The Pebble Project Draft Compensatory Mitigation Plan (January 2020) provides no habitat replacement or preservation to offset thousands of acres of wetland and aquatic habitats that the Pebble Mine Project would destroy, degrade, or fragment

A Report Prepared for Earthworks

The Alaska District of the Corps of Engineers' Revised Preliminary Jurisdictional Determinations for POA-2017-271 Inappropriately Reduces Estimates of the Direct Impacts of the Pebble Mine Project to Wetland and Aquatic Areas by Over 1200 Acres

Figure 1. Photos of a beach on Kamishak Beach included in PLP's January 2020 Compensatory Mitigation Plan for Marine Debris Removal

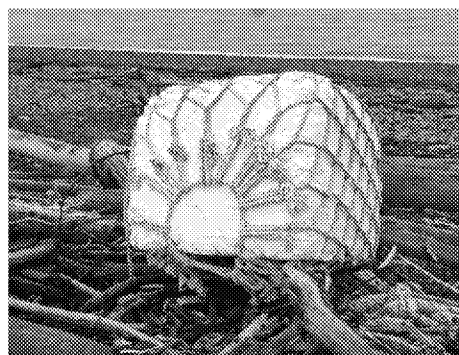
Even PLP's best efforts to depict the issue in photographs suggest that PLP is proposing to fix a problem that doesn't exist. Where one might expect to see images of a beach with heaping mounds of debris and potential sources of chemical pollution, the reader is presented with photographs of a plastic bucket, minor bits of floating debris, and a close-up of a net float (Figure 1), although PLP reports observing a "*variety of materials (e.g., plastic, metal, polystyrene foam), insulation materials (e.g., polystyrene foam sheets and fragments), barrels, buckets, plastic bottles, propane canisters, fish nets and seines, rope, pallets, lumber, coolers, fish totes, pressurized cannisters for paint and lubricant, tarps and fabric.*"³¹

Figure 1. Comparison of the Corps Alaska District's assertion of jurisdiction over wetland and aquatic areas at the Pebble Mine site in its DEIS and FEIS.

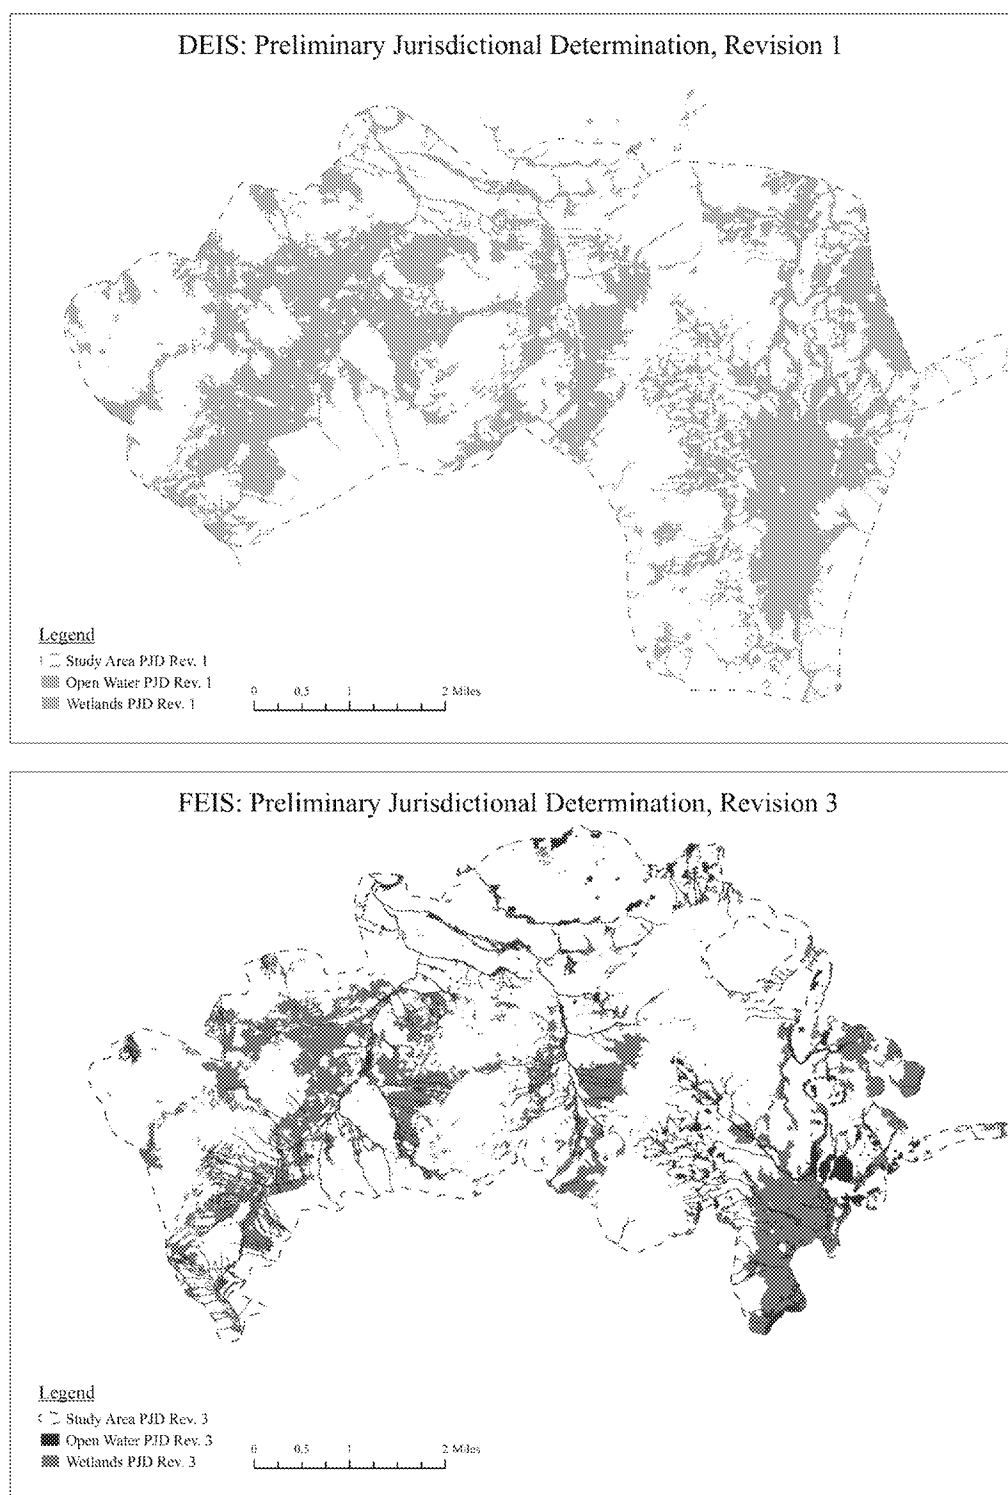
In October 2019, the Pebble Limited Partnership (PLP), applicant for the Pebble Mine Project, submitted revisions to its wetlands maps that were included in the February 2019 Draft Environmental Impact Statement (DEIS), claiming that its earlier estimates were far too large. Its revised maps claim that the Pebble Mine Project, as proposed, would destroy roughly 2 square miles less wetland and aquatic habitats than had been disclosed to the public in the DEIS, even though its project footprint had grown.

The U.S. Army Corps of Engineers, Alaska District (Corps) quickly adopted these revised estimates in December 2019 with no apparent independent field verification of any wetland/upland boundaries. These revisions are questionable for several reasons, and even if they could be confirmed in the field, these revised estimates should have been disclosed in a revised DEIS and not the Final EIS (FEIS). The Corps also adopted PLP's wetland and aquatic areas maps for the northern transportation corridor (Alternative 3), that became the applicant's preferred alternative prior to release of the FEIS. Those maps are also suspect, as they rely almost entirely on observations made between 2004 and 2008, yet somehow find about half as much of the corridor is wetlands than was estimated in 2011 on the basis of those same data. It is also disturbing that many sections of the newest mapping effort on the road alignment have no updated field sampling and, in several cases, are mapped with no field sampling whatsoever.

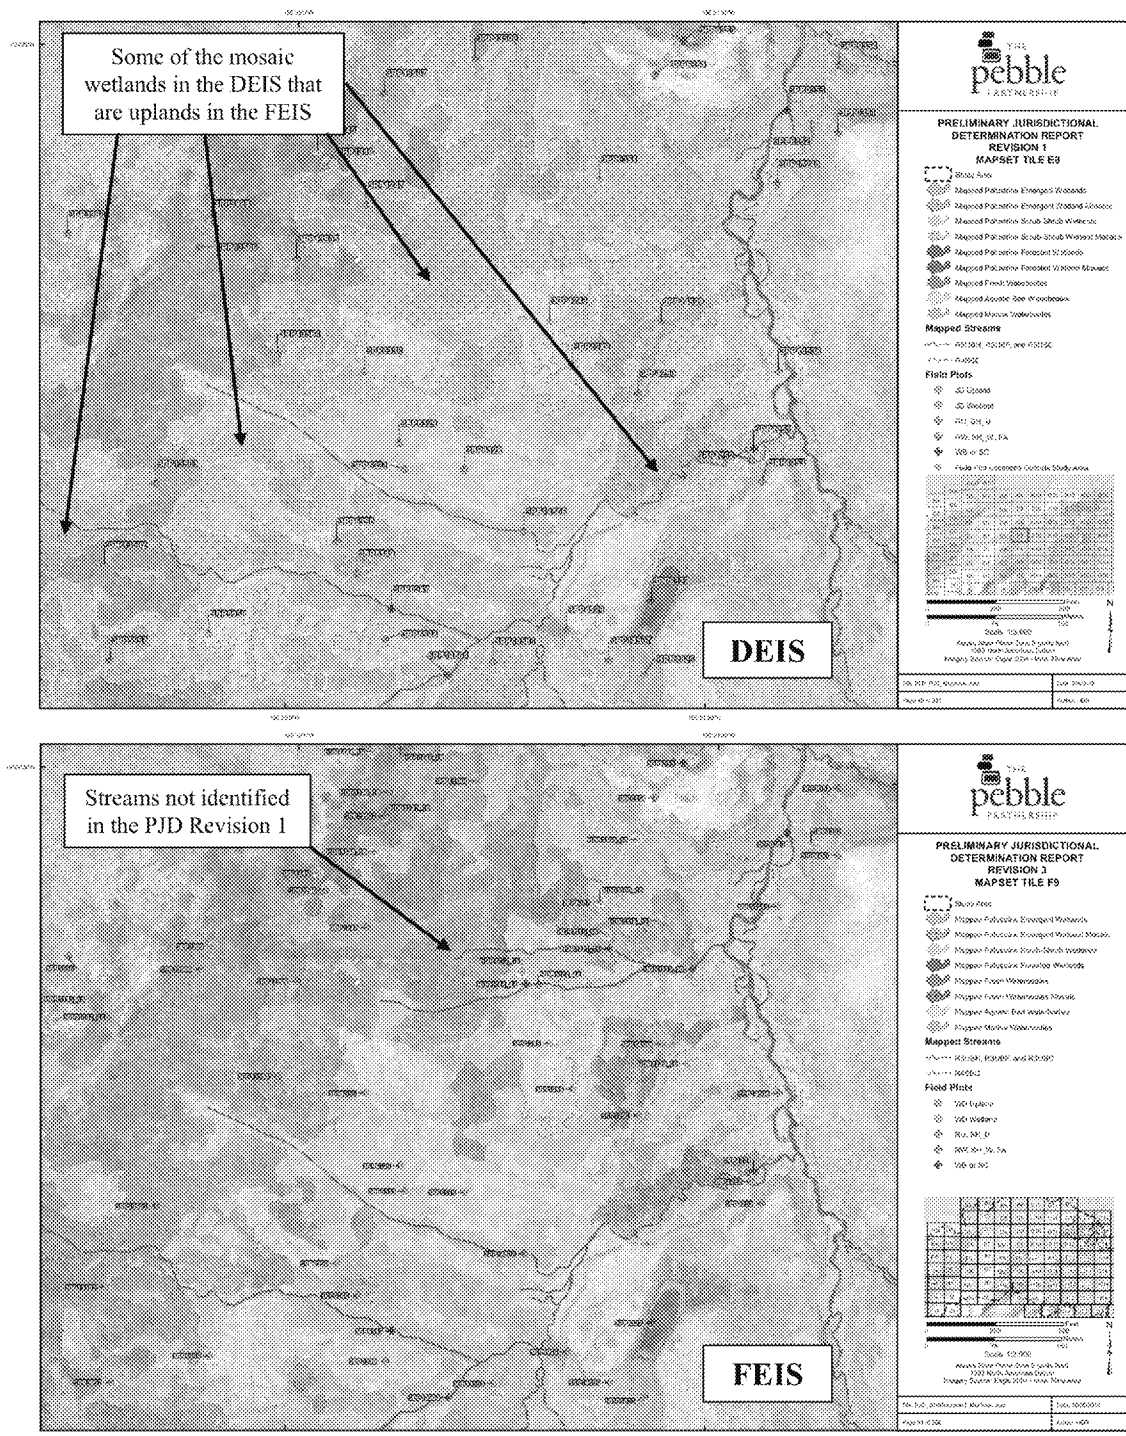
The applicant's introduction of a significantly smaller project study boundary in PJD#3 serves to complicate the analysis, as well as to reduce the usefulness of the overall mapping effort insofar as the NEPA analysis is concerned. The study area in the DEIS was 44,562.58 acres, whereas in the FEIS it has shrunk to 33,939.97 acres.

The new study boundary hugs the edge of the Pebble Project footprint, which might be appropriate for making a final determination of Clean Water Act jurisdiction pursuant to Section 404, but only if and when a permissible project footprint has been identified. However, at this

juncture, the truncated project study area unreasonably limits the depiction and disclosure under NEPA of the surrounding areas with regard to potentially less environmentally damaging sites

Figure 3. Comparison of wetlands mapped in the DEIS and FEIS for the Pebble Mine Project, as shown within Map Tile H5 (PJD Rev 3). Circled field sites were determined to be uplands by the Corps of Engineers despite strong field indicators for wetlands hydrology and hydrophytic vegetation.

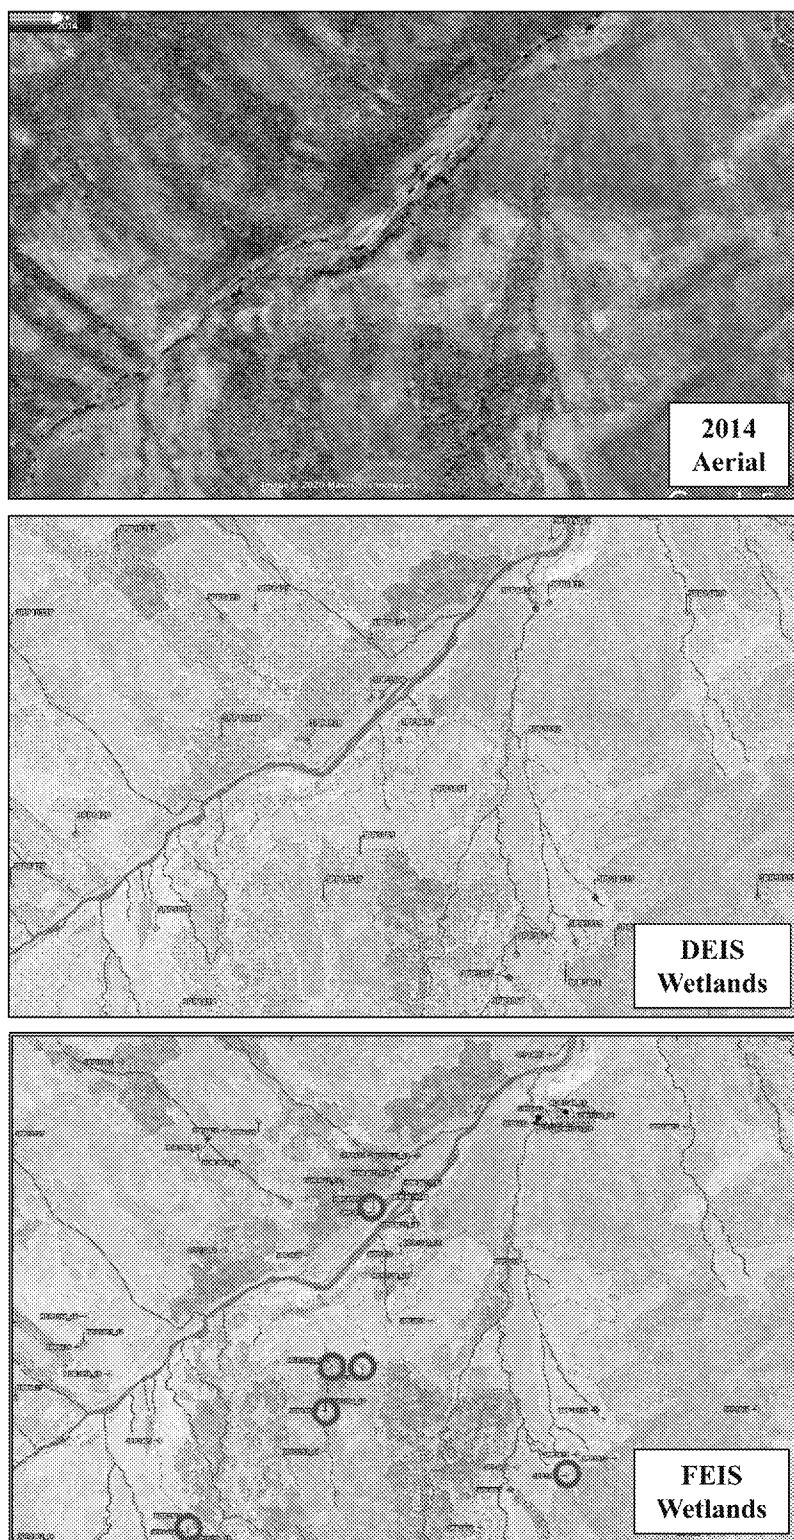
PJD#3 suffers from similar problems that were described for PJD#1.⁸ Many field sites where the applicant's consultants recorded strong field indicators hydrophytic vegetation and wetlands hydrology were dismissed as meeting the criteria for wetlands, when those field indicators should have led the delineators to conclude that the mandatory criteria for vegetation, hydrology, and hydric soils were, in fact, met (Figure 3).

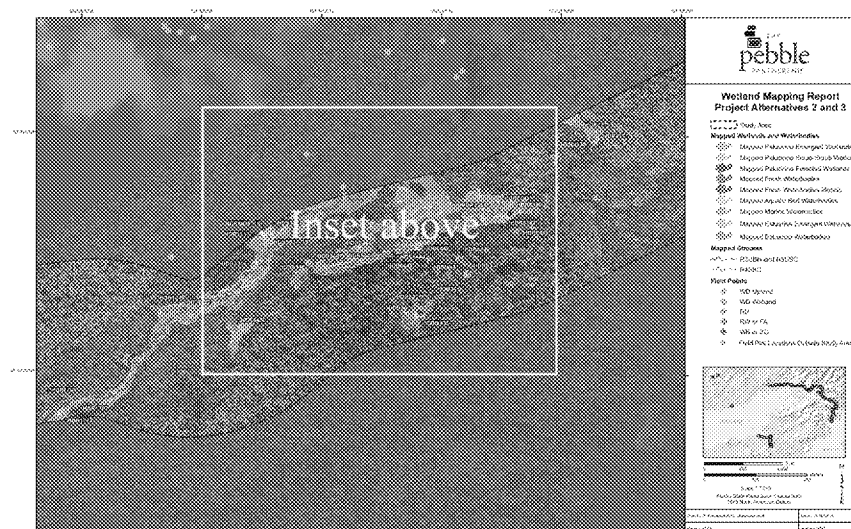
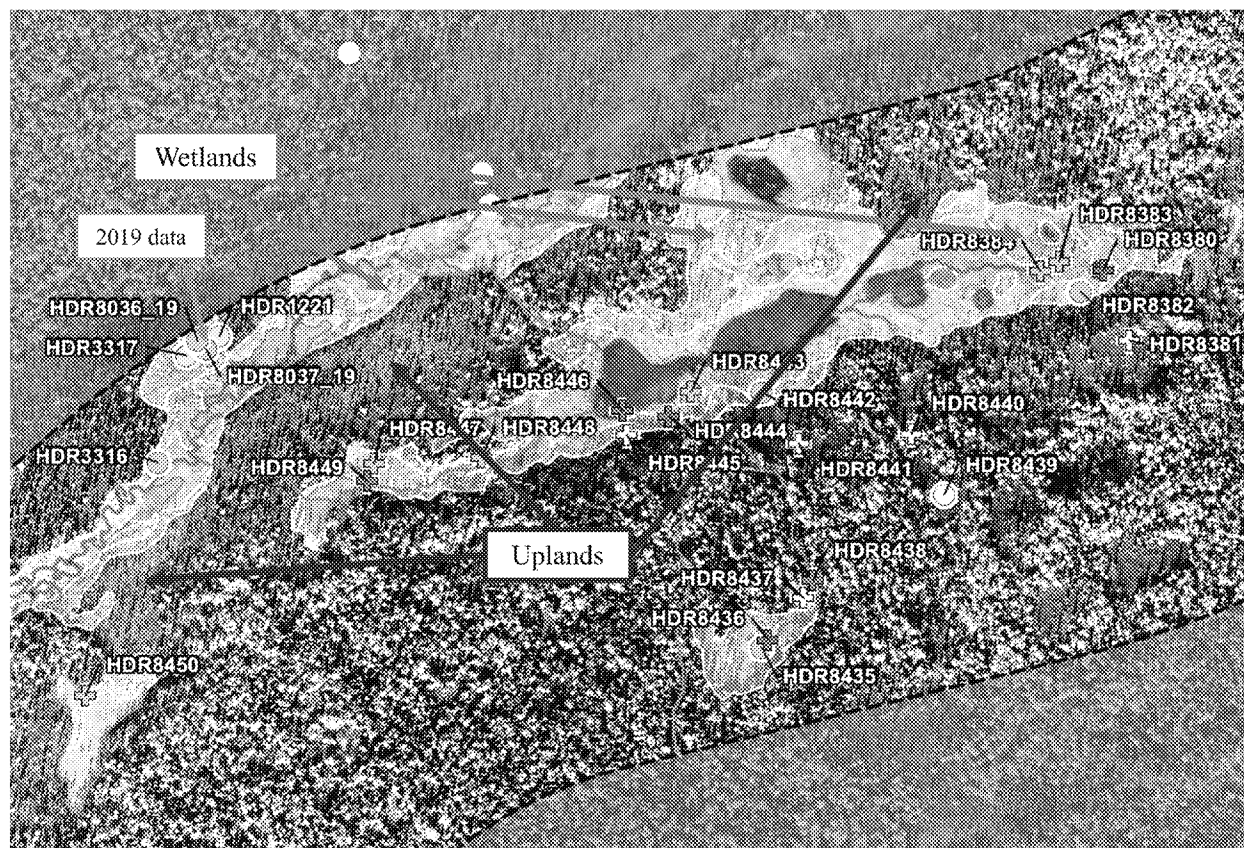
requests for any such corrections from the applicant on its rush to complete the FEIS and, presumably, to quickly issue a record of decision (Figure 4).

Figure 3. Soil chemical properties and NRCS soil survey map. The NRCS soil survey data is open to the public. A screenshot of the drop-down soil chemical properties and erosion factors is shown. *Source: <https://websoilsurvey.nrcs.usda.gov/app/WebSoilSurvey.aspx>*

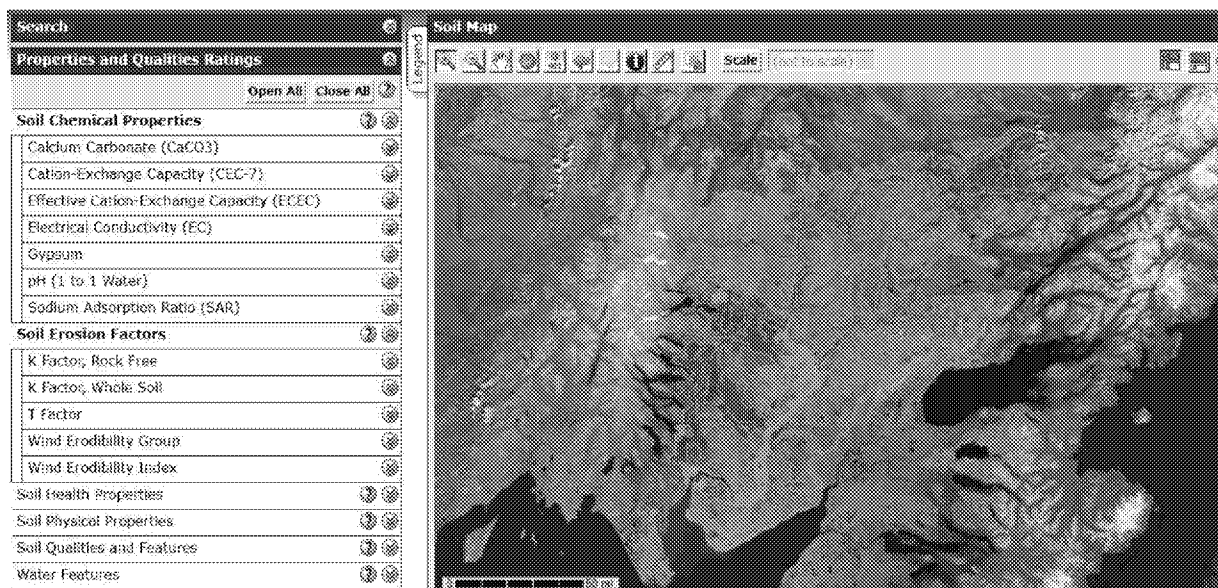
Literature review is necessary but not complete in and of itself. PLP environmental baseline contractors should collect original soil type and chemistry data at the mine, ports, and road corridor sites likely to be impacted. Without this, there is no way to properly assess potential impacts in the DEIS, nor will it be possible to determine actual impacts from the mining project in the future.

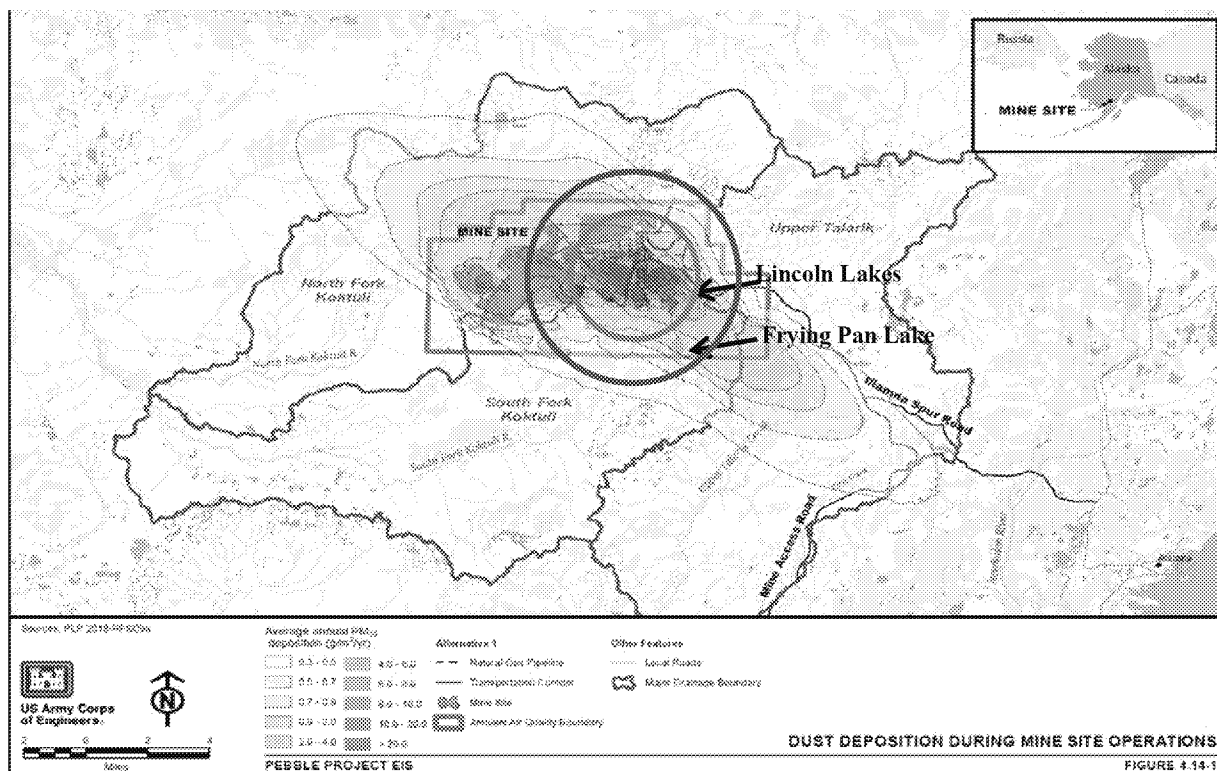
The Pebble Project DEIS appears to acknowledge a much more extensive deposition zone than 100 m (Figure 5), but whether all water bodies within the plume shown in the figure were included in the listed acres of wetlands, ponds, and streams is not clear, as there are no maps to convey the information.

The dust plume figure (DEIS Figure 4.14-1 shown in Figure 5 of this memo) should include the locations of all the meteorological stations, and, if data from only some stations is used, identify those on the figure. It should describe the range of wind speeds observed at the different stations and how those were applied in determining the dust plume deposition zone.

Deposition rates will decrease with distance (Figure 5), but only a single deposition rate was applied to the calculations of particle deposition and resulting metal accumulations. The deposition rate of $0.056 \text{ g/m}^2\text{-d}$ and $2.05 \text{ g/m}^2\text{-yr}$ was applied when determining the accumulation of metals in soil (RFI 009 Table 1.3), and may severely underestimate the actual rate of dust fall and resulting accumulation of metals. Even if the daily rate were accurate, a simple calculation of the daily rate times 365 days per year results in $20.4 \text{ g/m}^2\text{-yr}$, not $2.05 \text{ g/m}^2\text{-yr}$. This needs to be explained in a Revised DEIS.

Figure 8. Baseline sediment and water quality sampling sites, mine area.

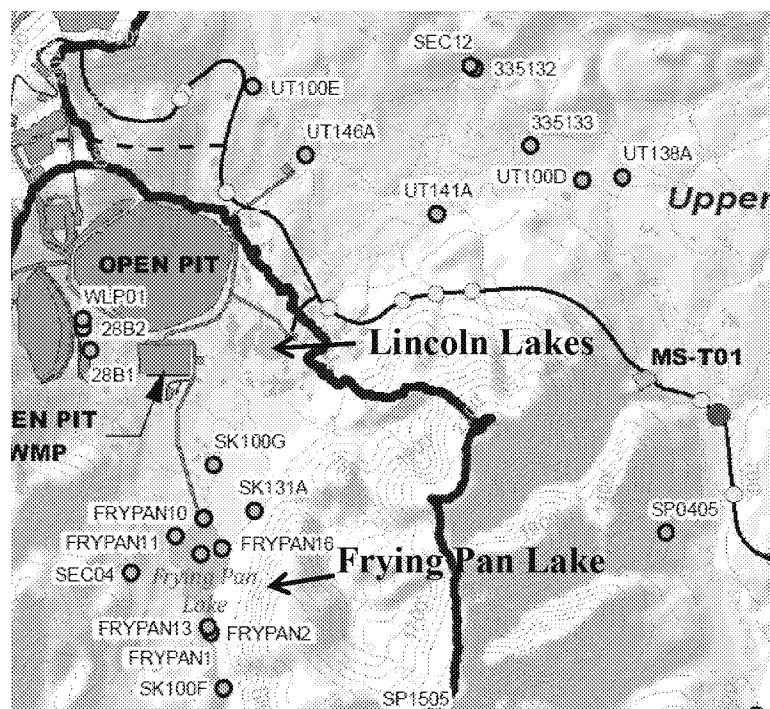
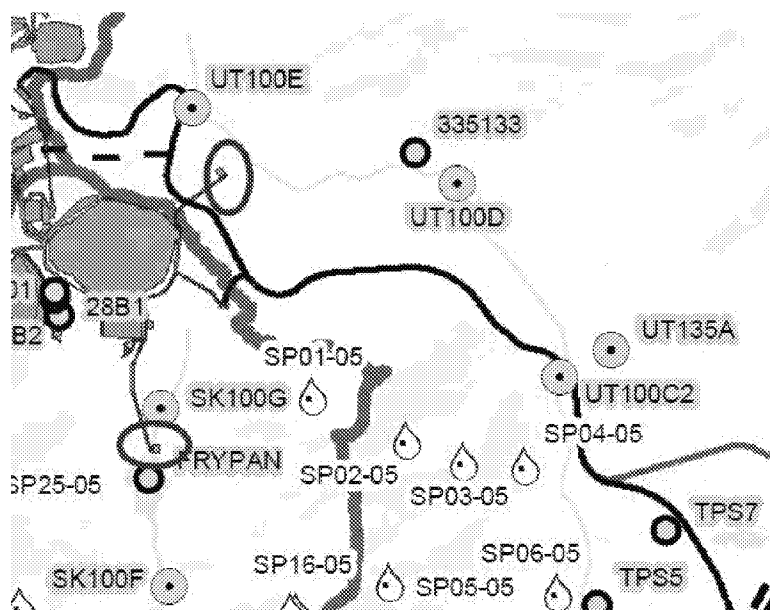
Baseline soil chemistry sampling was conducted at 117 locations, but there is no map or list of their locations in DEIS Chapters 3.14, 4.14, or Appendix K3.14, therefore there is no way to determine if they were representative either geographically or with respect to soil type. It appears that the sites, as shown in the Environmental Baseline Document (EBD), are scattered throughout the general area and only five to

Several ponds, streams, and wetland sites were sampled for baseline trace element chemistry (SLR et al. 2011). However, Lincoln Lakes and ponds around them that are in the path of fugitive dust have not been sampled. Only part of the area the plume will impact is shown; a similar area to the northwest will also be impacted.

(Upper) The map shows sediment sample sites (DEIS Figure 3.18-3). There are many water bodies southwest of the pit that have no sediment samples.

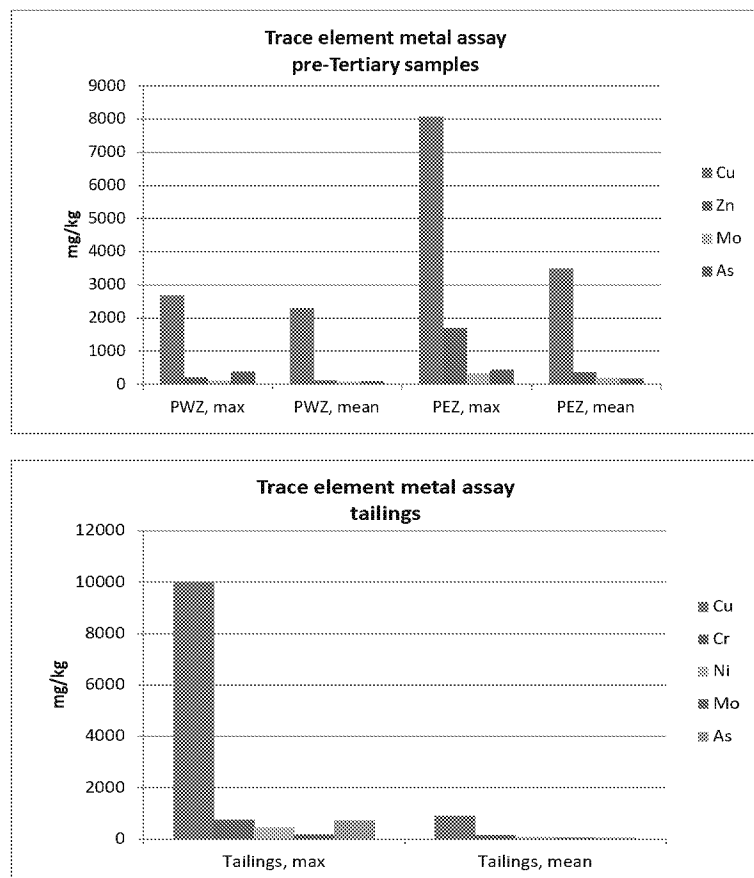
Metal assay testing also confirms that Cu is the primary trace metal in pre-Tertiary rock (PLP 2018 Table 11-10) and tailings (PLP 2018 Table 11-30) (Figure 9). Metal assays for Tertiary samples were not available. Thus, omitting Cu from the analysis of dust is unjustifiable and needs to be remedied in the Revised DEIS.
